# HISTORIC AND DESIGN REVIEW COMMISSION

**HDRC CASE NO:** 2020-323  
**ADDRESS:** 435 MISSION ST  
**LEGAL DESCRIPTION:** NCB 946 BLK 2 LOT 26, 27 & 8.1 FT STRIP ALONG THE S SIDE  
**ZONING:** RM-4, H  
**CITY COUNCIL DIST.:** 1  
**DISTRICT:** King William Historic District  
**APPLICANT:** Nicholas Melde/Architexas  
**OWNER:** Colin and Tamanna O'Dea/ODEA COLIN M & TAMANNA  
**TYPE OF WORK:** New construction of 2-story residential structure and a 2-story rear accessory structure  
**APPLICATION RECEIVED:** October 30, 2020  
**60-DAY REVIEW:** Not Applicable Due to City Council Emergency Orders  
**CASE MANAGER:** Rachel Rettaliata  
**REQUEST:**

The applicant is requesting a Certificate of Appropriateness for final approval to construct a 2-story residential structure.

**Historic and Design Review Commission  
Design Review Committee  
Report & Recommendation**

# Architect Series® Traditional Hung Window

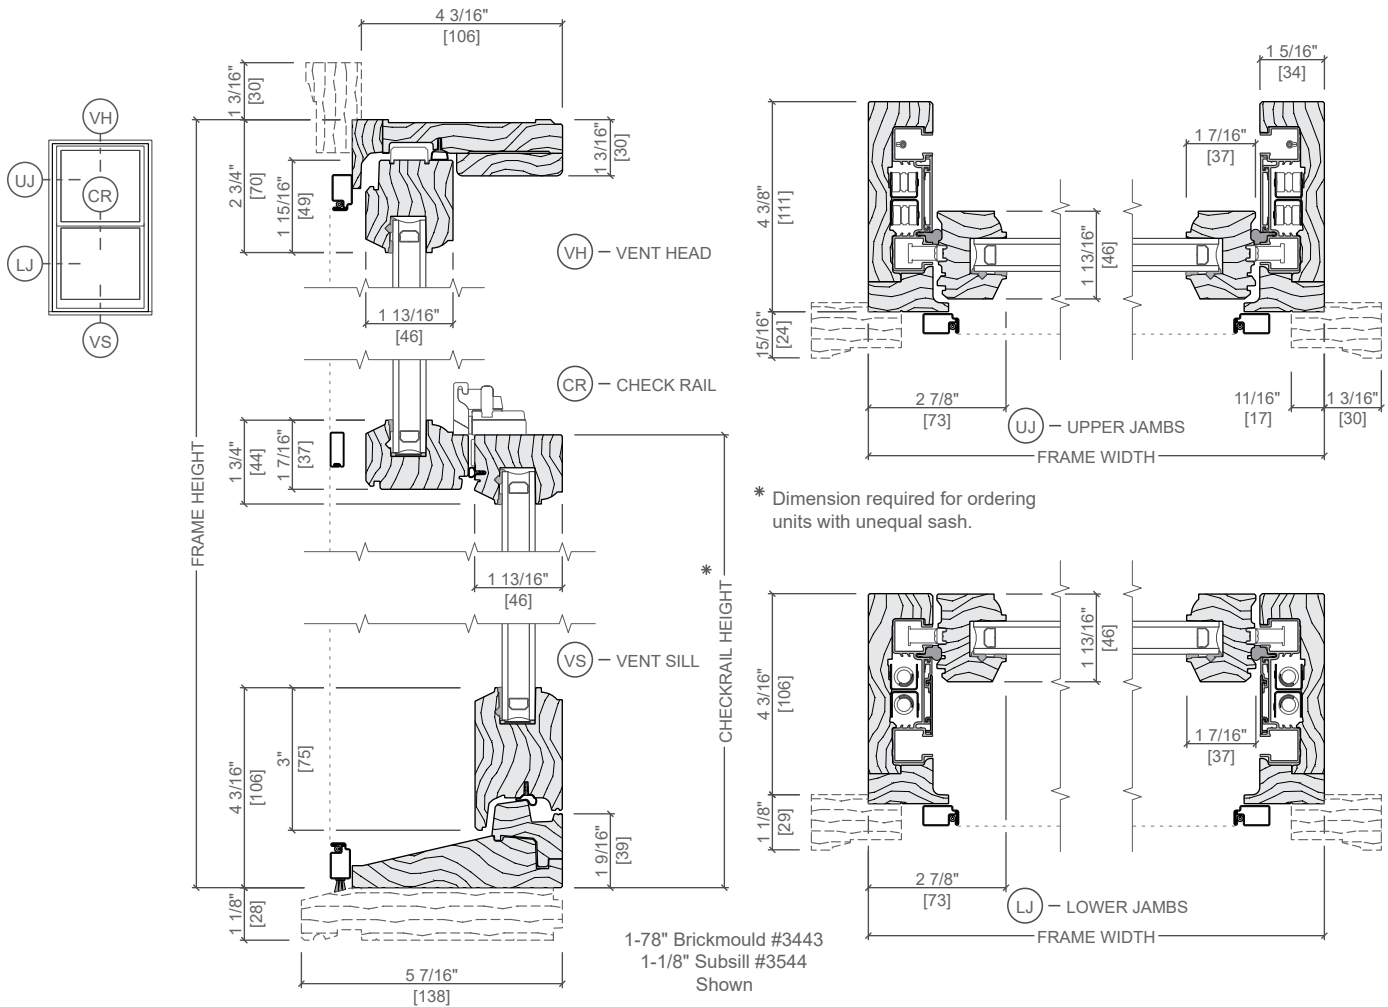
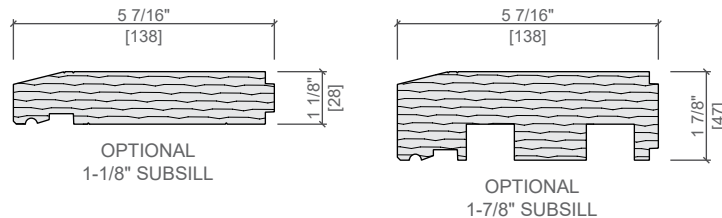
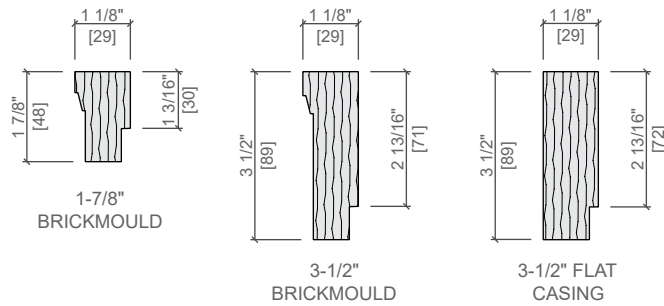
- i. **WINDOW MATERIALS** – The applicant has proposed to install Pella Architect Series Traditional Hung fully wood windows. Wood or aluminum-clad wood windows are recommended and should feature an inset of two (2) inches within facades and should feature profiles that are found historically within the immediate vicinity.

An alternative window material may be proposed, provided that the window features meeting rails that are no taller than 1.25" and stiles no wider than 2.25". White manufacturer's color is not allowed, and color selection must be presented to staff. There should be a minimum of two inches in depth between the front face of the window trim and the front face of the top window sash. This must be accomplished by recessing the window sufficiently within the opening or with the installation of additional window trim to add thickness. Window trim must feature traditional dimensions and an architecturally appropriate sill detail. Window track components must be painted to match the window trim or be concealed by a wood window screen set within the opening. Staff finds the proposal appropriate.

- i. That the applicant submits final material specifications to staff for review and approval based on finding h.
- ii. That the applicant installs fully wood windows that meet staff's standard window specifications based on finding i. Wood or aluminum-clad wood windows are recommended and should feature an inset of two (2) inches within facades and should feature profiles that are found historically within the immediate vicinity. Meeting rails must be no taller than 1.25" and stiles no wider than 2.25". White manufacturer's color is not allowed, and color selection must be presented to staff. There should be a minimum of two inches in depth between the front face of the window trim and the front face of the top window sash. This must be accomplished by recessing the window sufficiently within the opening or with the installation of additional window trim to add thickness. Window trim must feature traditional dimensions and architecturally appropriate sill detail. Window track components must be painted to match the window trim or concealed by a wood window screen set within the opening.

ACCESSORY DWELLING - SECOND FLOOR PLAN  
 SCALE: 1/4" = 1'-0"

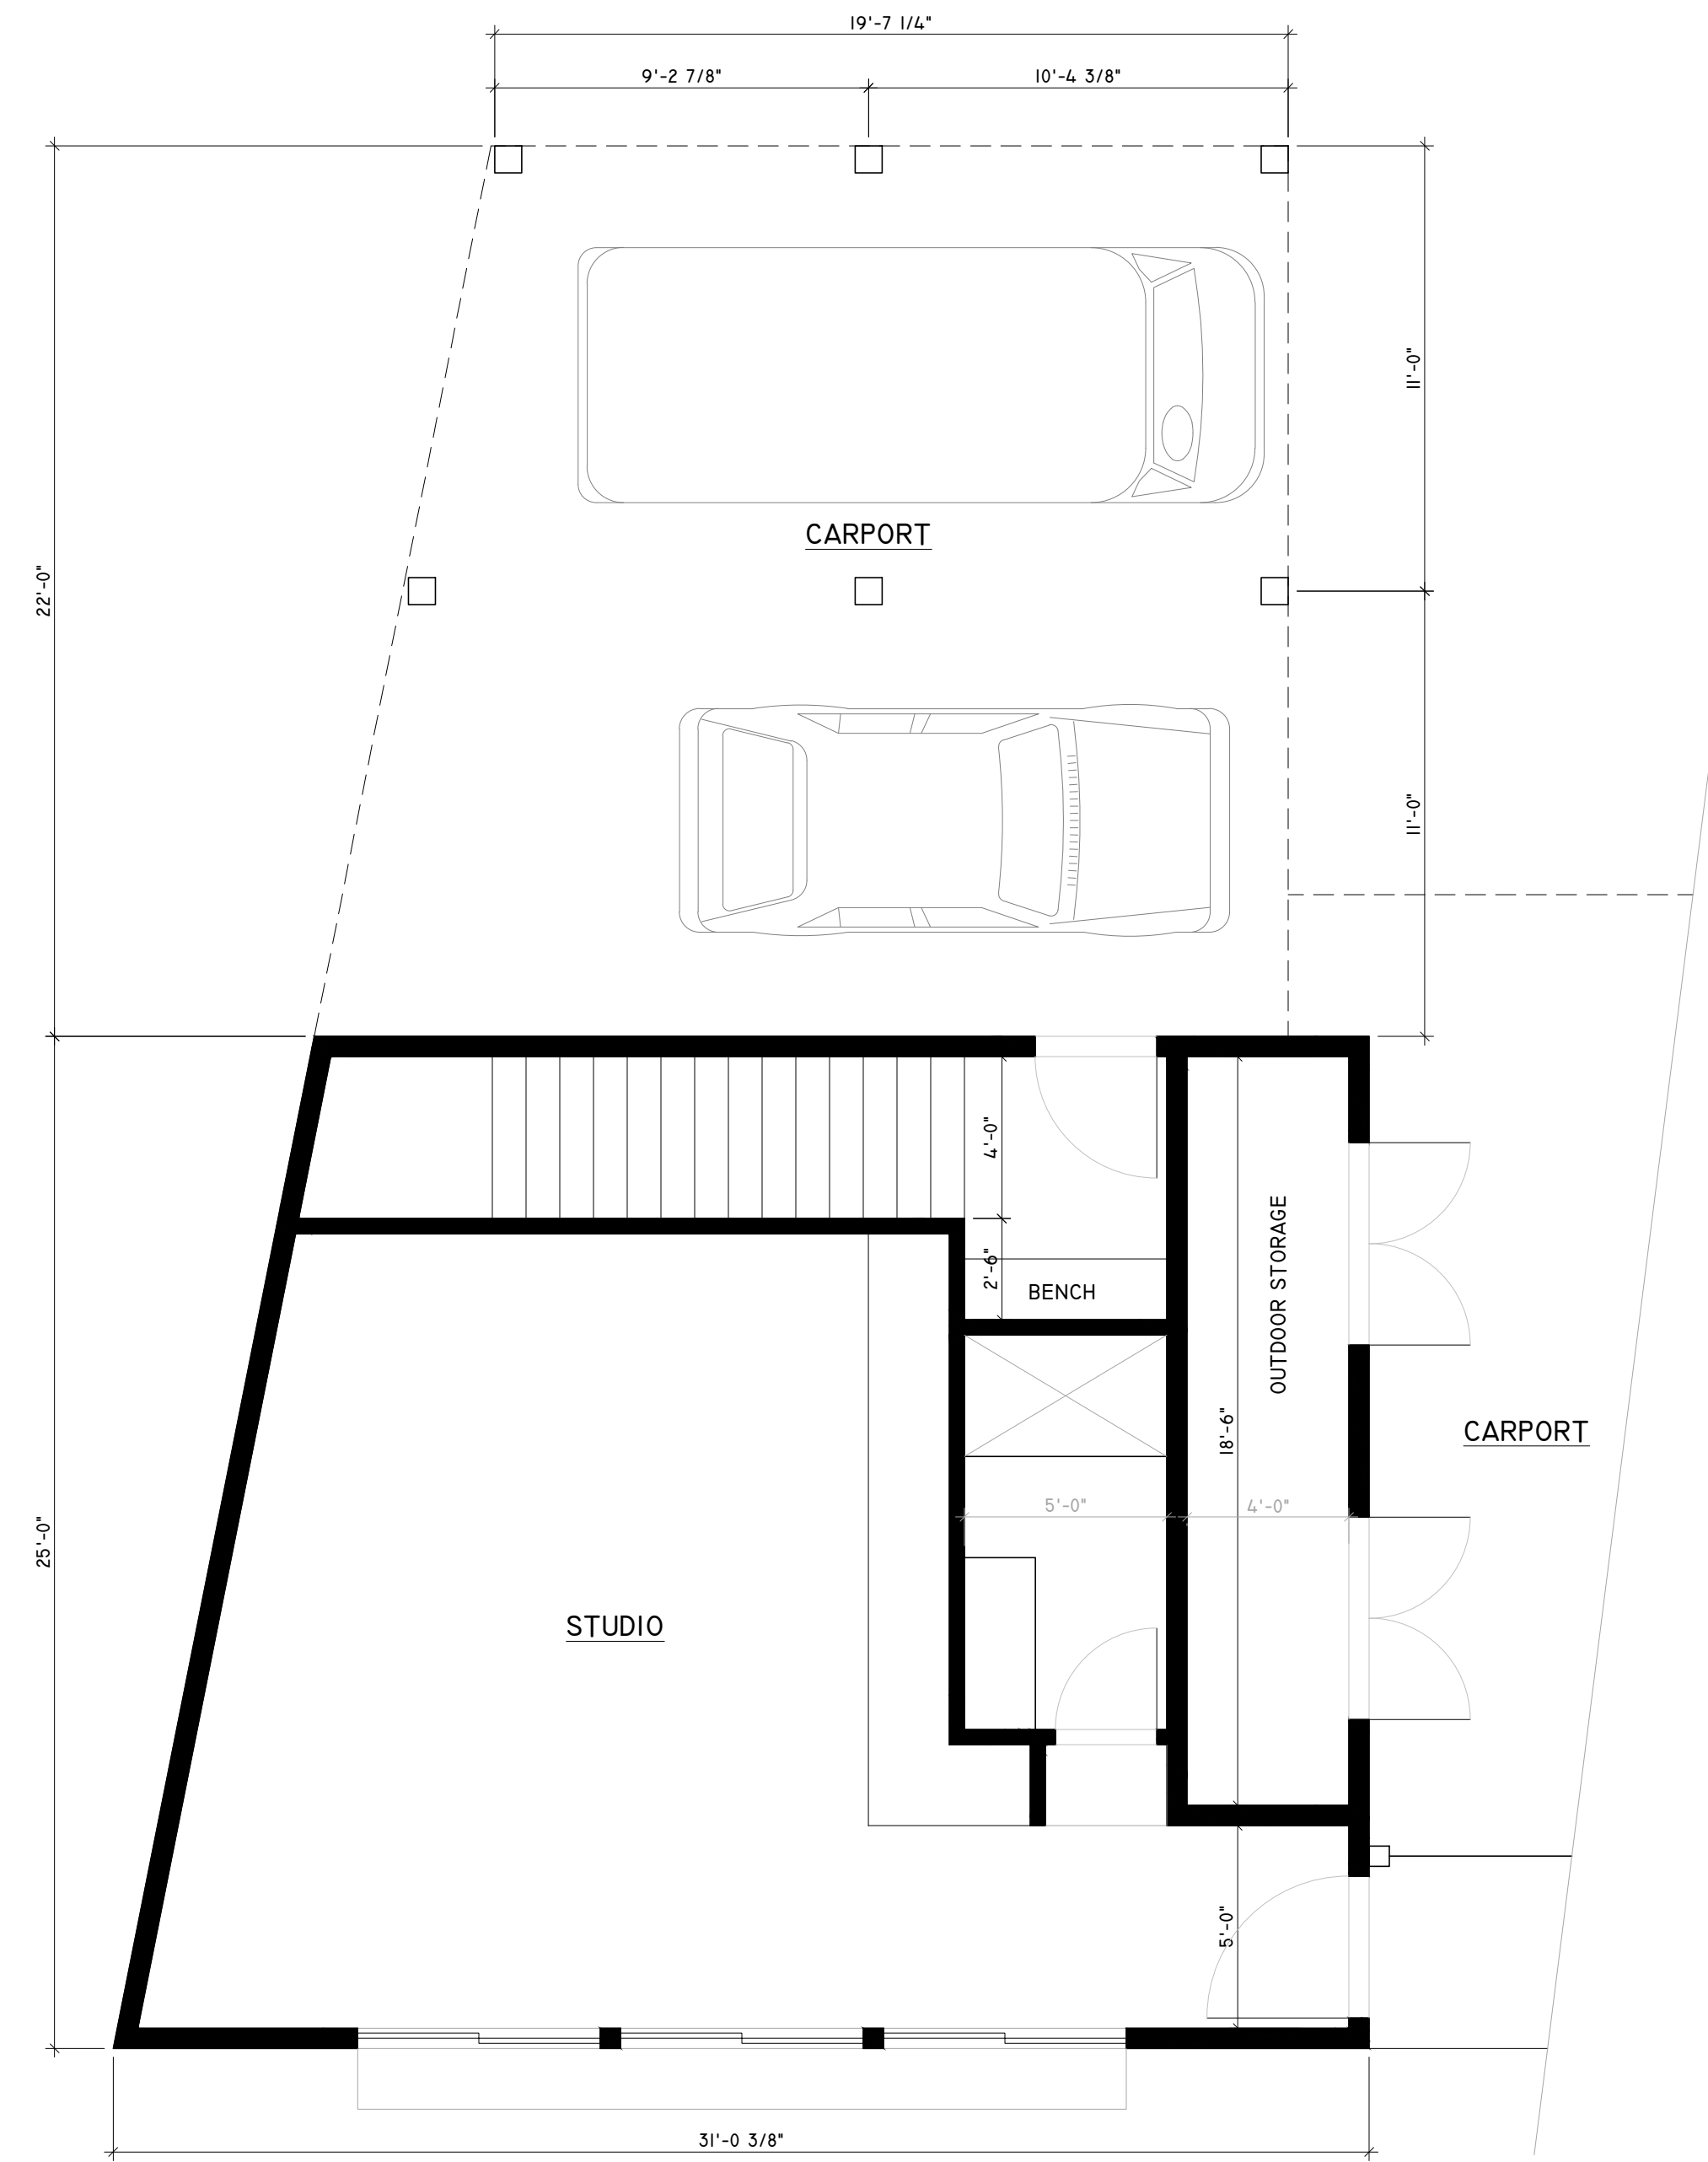
JF: One question I've got is the height of the accessory structure, with the tall 12:12 pitches, the accessory structure looks really tall.

JF: Dropping the height of the accessory structure, are there any other 2-story accessory structures on this block that you could provide precedent images for?
